From:	Justin Simons <justins@georgetown.tas.gov.au></justins@georgetown.tas.gov.au>
Sent:	Thursday, 1 June 2023 12:28 PM
То:	TPC Enquiry; Barlund, Paola
Cc:	James Stewart; Andrew McCarthy; McCrossen, Samuel
Subject:	George Town Draft LPS - Directions - Planning Authority 2
Attachments:	QA - Flood-prone Hazard Areas Code - May23 (Depth_0.1m).pdf; 20230601 George Town Flood-Prone Area Rationalisation Memo.pdf

Flood-Prone Hazard Areas Code - Proposed changes (D>0.1m, D.V>0.02m2/s, A>100m2)

Re: FLOOD PRONE HAZARD AREAS OVERLAY AMEMENDMENT FILTERING

Legend

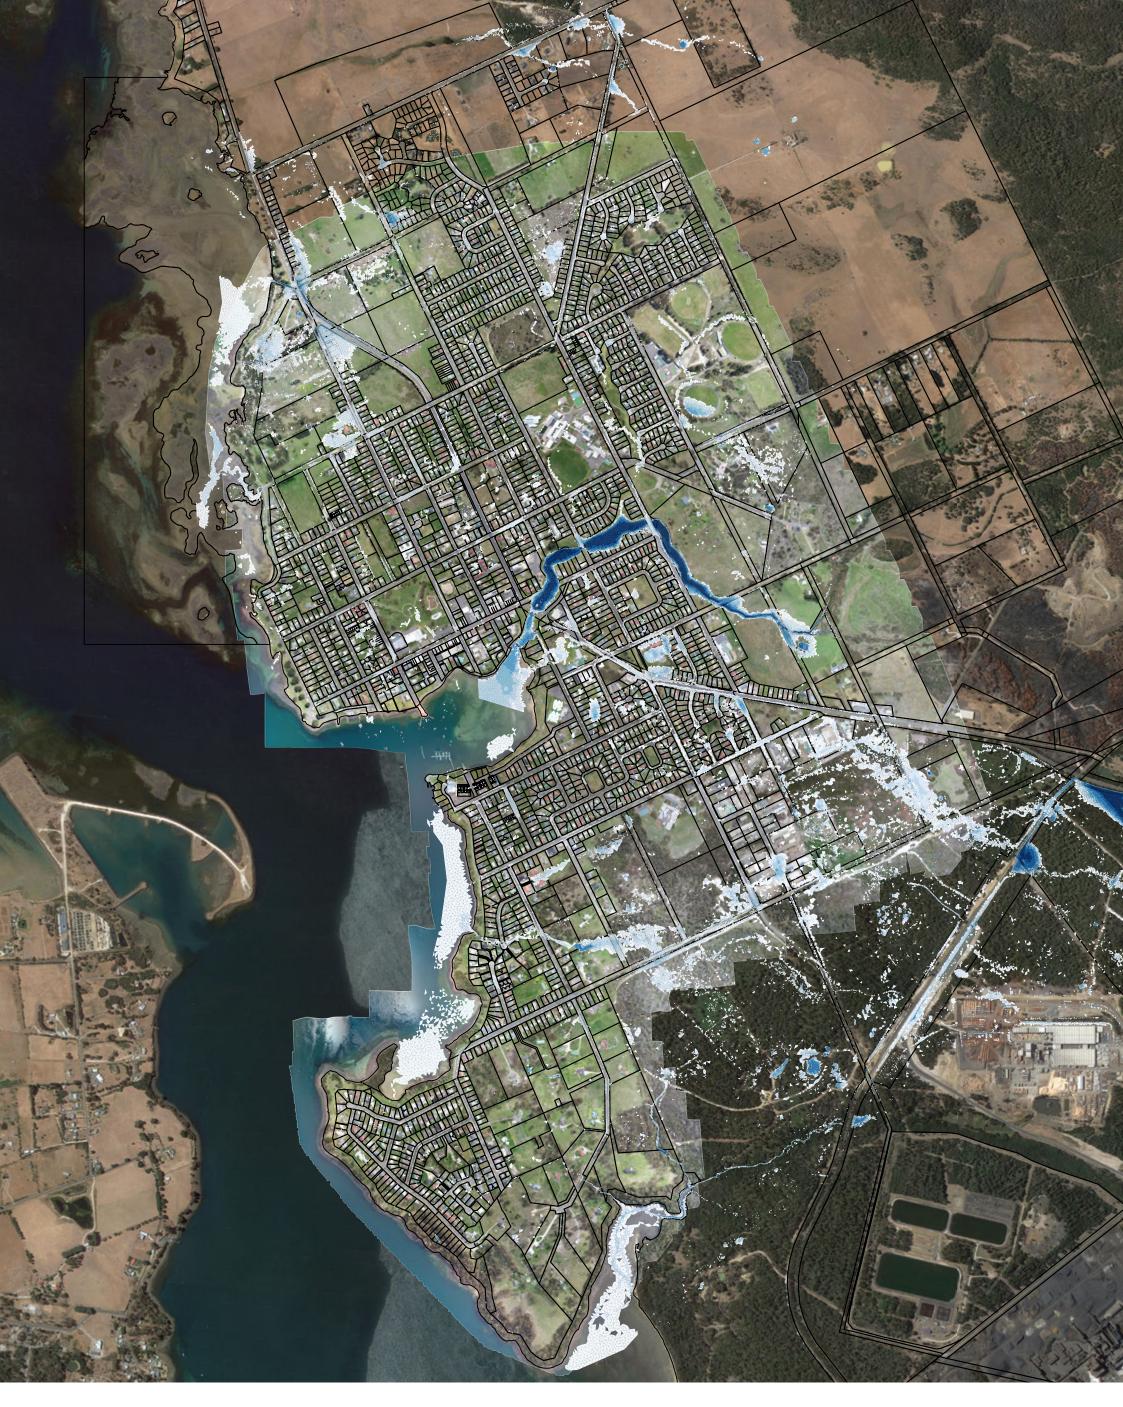
After reviewing the original flood mapping, and GTCs proposed thresholds, Hydrodynamica and GTC propose a Flood-Prone Hazard Area based on the following revised thresholds:

- Depth > 0.1m (100mm); or
- Depth x velocity product >0.02m²/s; and
- Ponding >100 m² in total area

It is our opinion that the proposed levels are appropriate, as the depths removed are extremely unlikely to have removed any flooding which would enter a dwelling. The removed flooding is marginal outdoor flooding which holds little to no risk to people or property. Flooding of less than 100mm depth would require a velocity of 2 m/s in order to raise the risk to a H2 HVC level, at which point it becomes unsafe for small vehicles. Although York Creek runs through the urban area, which results from runoff from the elevated Mount George and George Town Sugarloaf, the George Town urban area itself relatively flat and not subject to significant velocities.
